RE: RESPONSE TO REQUEST FOR FURTHER INFORMATION - 757 - 763 GEORGE STREET, HAYMARKET

This letter has been prepared on behalf of Samprian Pty Ltd (the Applicant) in relation to their land at 757 – 763 George Street, Haymarket (the site). The site is the subject of a Planning Proposal (PP ref no PP-2020-1110.) that seeks to amend the height of buildings and floor space ratio (FSR) development standards that apply to the site under the *Sydney Local Environmental Plan 2012* (Sydney LEP 2012). The purpose of this letter is to respond to the issues raised by the City of Sydney (Council) in their Request for Information letter dated 22 February 2021.

# 757—763 George Street Planning Proposal

Figure 2 – Revised Setback Arrangement Source: Grimshaw (Urban Design Report Dated October 2021)

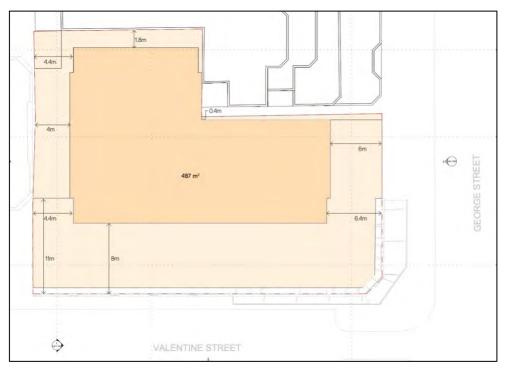
- Building separation to Capitol Terrace;
- Wind impacts in the public domain resulting from the building envelope; and
- Vertical separation between the proposed envelope overhang and the heritage Sutton Forest Meat building.

- The increased building separation of the upper level setback of 3m should be maintained;
- The minimum northern building separation to Capitol Terrace be increased to a minimum of 2.8m;
- The minimum southern boundary setback of 8m be maintained as per the initial plans; and
- The western boundary setback of 4m be maintained as per the initial plans;

In response to Council's feedback, the northern setbacks have been revised. Specifically, the following amendments have been made:

In accordance with Council's written request as outlined in the Request for Information letter (dated 22 February 2021), the northern setback has been revised to reflect the setbacks provided by Capitol Terrace. At its narrowest point, the northern setback to the common boundary reaches 1.6m. The building known as Capitol Terrace provides a 1.2m setback to its boundary. Combined, the total building separation between the two developments amounts to 2.8m.

The western setback to 187 Thomas Street has been reduced from 4.4m to 3m. The setback complies with the Sydney DCP 2012, however, contravenes the Draft CSPS DCP which nominates a 4m setback for a building of the proposed height. The reduced setback has been determined with reference to the setback associated with the scheme proposed for 187 Thomas Street which initially proposed a 1m setback to its eastern common boundary. Council has confirmed via written correspondence dated 16 April 2021 that a 3m setback may be considered reasonable if the scheme is able to satisfy the environmental equivalence testing set out by Procedure B, Schedule 11.

A comparison between the former and revised setbacks is provided in the figures below and the Amended Architectural Plans at Attachment 1.
